**SUBJECT: Response to Request for Additional Information (RAI),
Suwannee American Cement**

SUBJECT: Response to Request for Additional Information (RAI), April 15, 2005
Suwannee American Cement – Branford Plant
DEP File No. 1210465-014-AC (PSD-FL-352)
Proposed New Kiln at the Branford Cement Plant in Suwannee County, Florida

**REVISED AIR DISPERSION MODELING REPORT
FOR PSD PERMIT APPLICATION
SUWANNEE AMERICAN CEMENT**

Figure 1. PM₁₀ Monitoring Near SAC in Branford, Florida

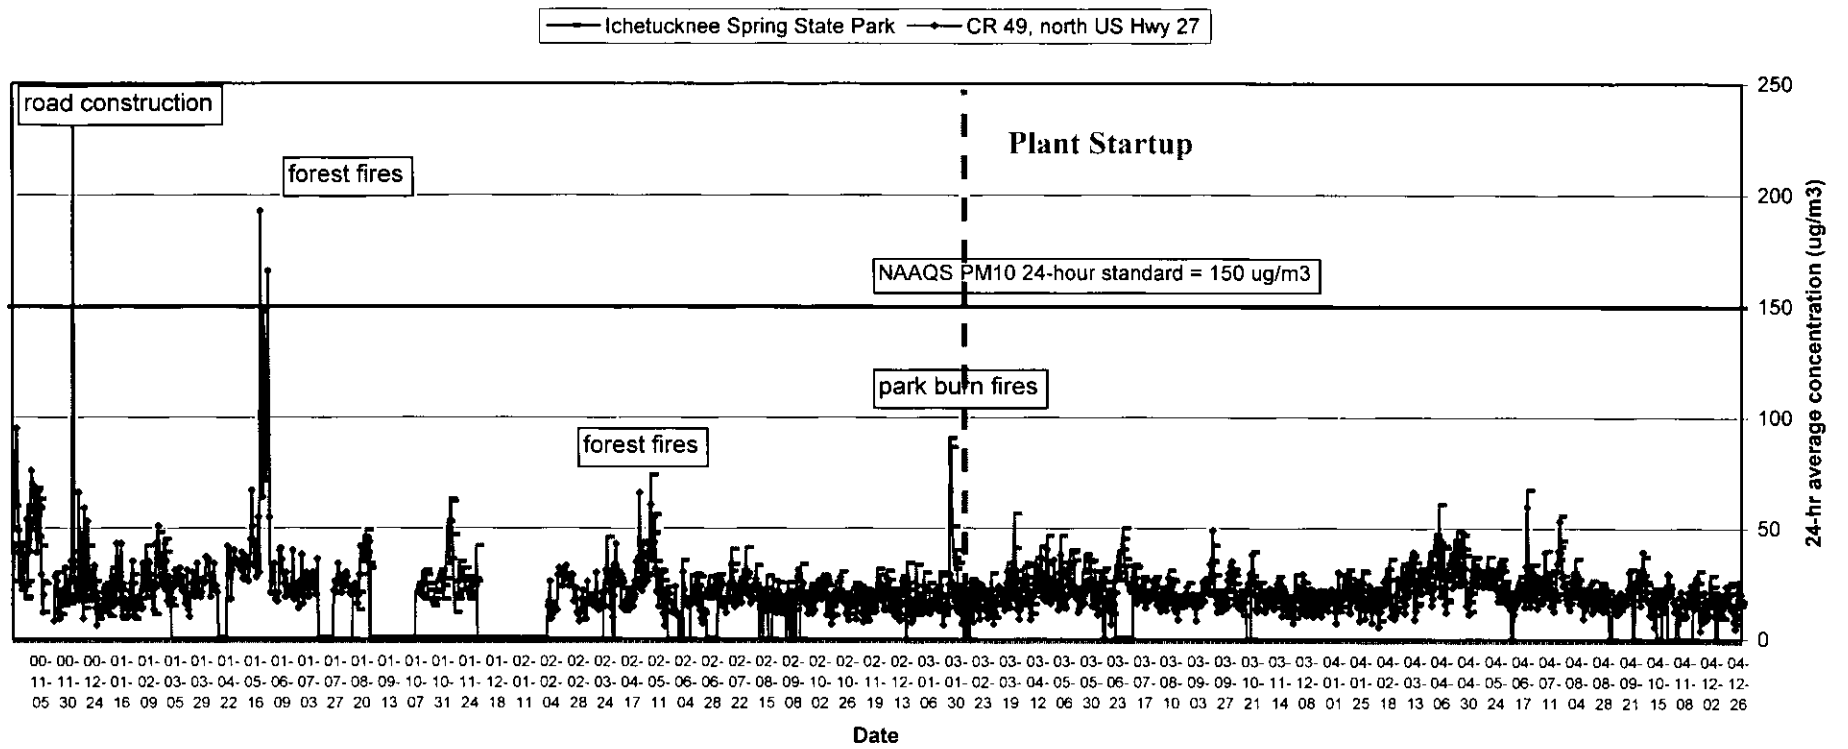
7. *The Florida Park Service has concerns about the air quality impacts in the Ichetucknee Springs State Park from this project. Please address these impacts on this Park and discuss the results of the PM_{10} ambient monitoring data collected in this Park.*

Comparison to PM₁₀ monitored data taken at the Ichetucknee State Park shows the proposed project impacts will be less than 10 percent on an average 24-hour basis. Over the past three years the average 24-hour concentrations of PM₁₀ in Ichetucknee were:

The maximum 24-hour PM₁₀ contribution of the new line to the existing PM₁₀ monitor is predicted to approximate 7 percent change on the average 24-hour concentration. Adding the maximum new kiln line concentration (to Ichetucknee, regardless of the location in the Park) of 2 µg/m³ to the average 2004 24-hour concentration of 30 µg/m³ results in an impact of 32 µg/m³ on an average 24-hour basis, which is still only 21 percent of the NAAQS. Figure 1 shows a graphical historical presentation of ambient PM₁₀ monitoring data taken at both a West PM₁₀ monitor (west of the SAC Plant fence line, shown in blue) as well as the PM₁₀ monitor at Ichetucknee (shown in red). As can be seen, the maximum impact at Ichetucknee was 91 µg/m³ in early 2003 prior to the start up of the existing facility. This concentration was related to a Park prescribed burn. Maximum concentrations on a 24-hour basis are generally less than 50 µg/m³ or less than 33 percent of the NAAQS (shown as a horizontal line across the graph). Even considering the PM₁₀ concentrations after SAC plant start up on February 17, 2003, few concentrations are greater than 50 µg/m³. Combining the proposed line impacts with the highest values in the 55 to 65 µg/m³ range results in concentrations much less than 50 percent of the NAAQS. Additionally, from Figure 1 it is seen that little difference can be from the period prior to startup of the existing facility to periods after the startup.

Figure 2-2. SAC Facility Building and Source Configuration

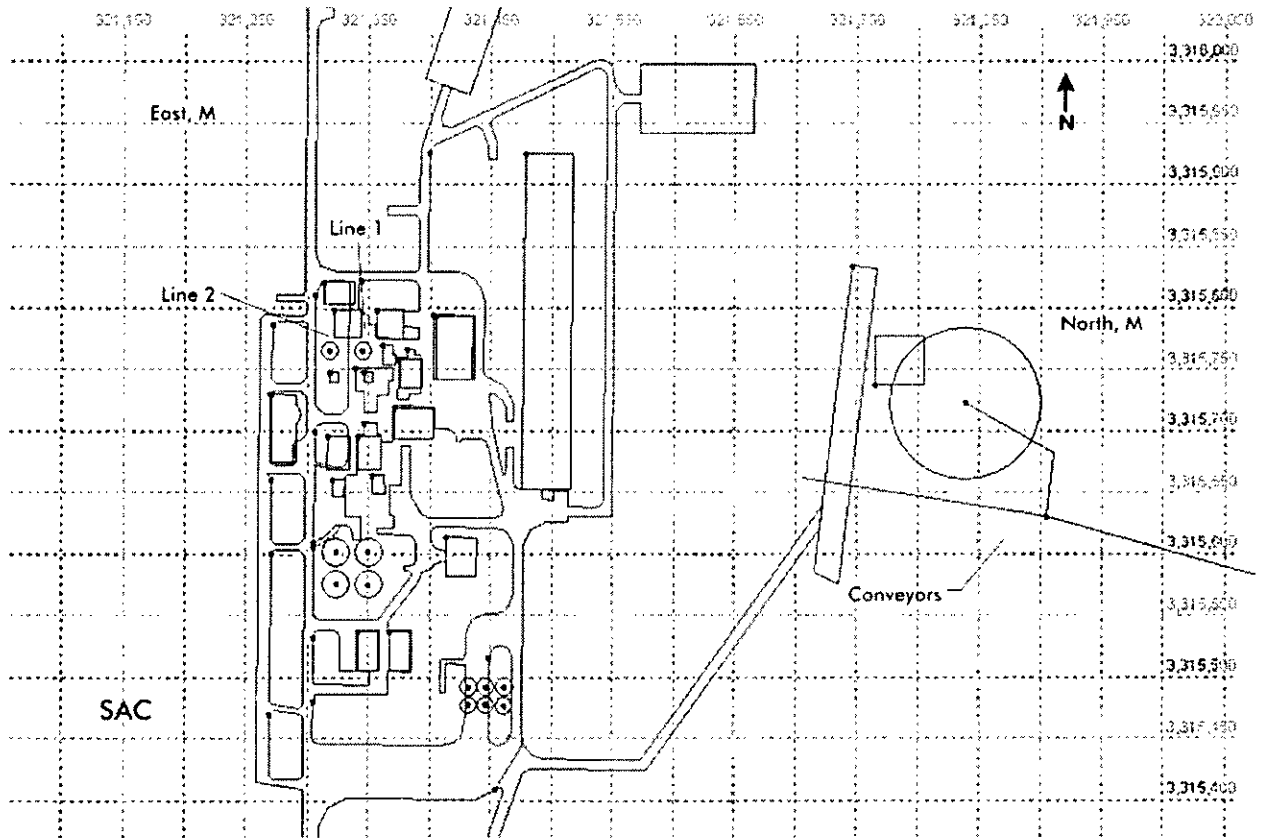
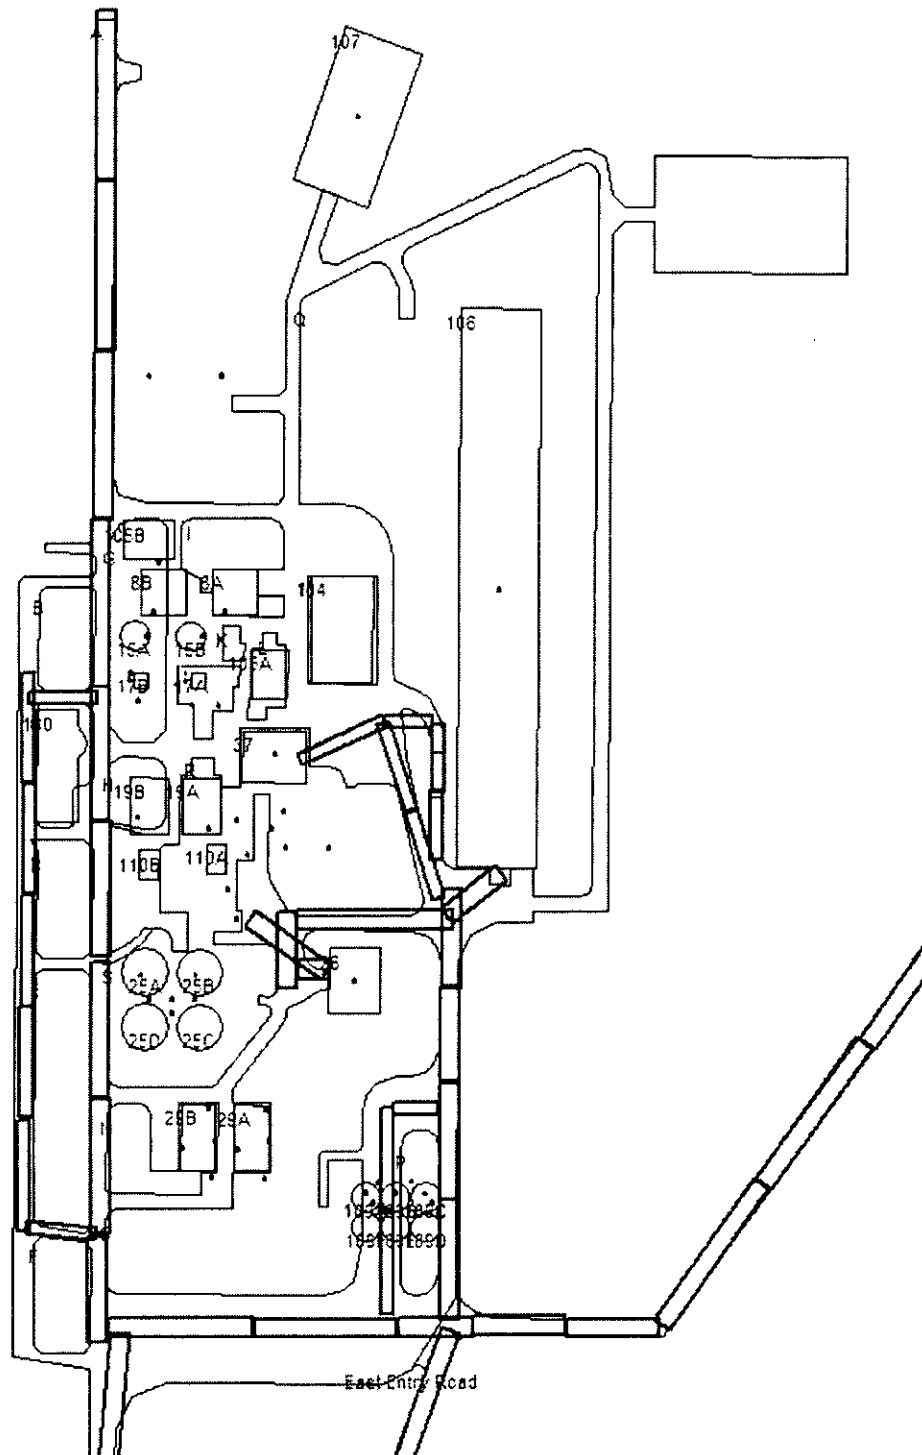
5. *Please update Figure 2-2 with the detailed building structure information used in the modeling to determine downwash impacts. This information should include building dimensions for all buildings used in the modeling analyses. All stacks and buildings should be labeled. Additionally fence lines or physical barriers which preclude access to nonambient air should be shown. Nonambient air is the atmosphere over land owned or controlled by the source and to which public access is precluded by a fence or other physical barrier.*

The enclosed Modeling Report has been revised to include the requested information in Figure 2.3 and Table 2.1. SAC maintains fencing around the entire property boundary. This fence line is shown in Figure 2.1.
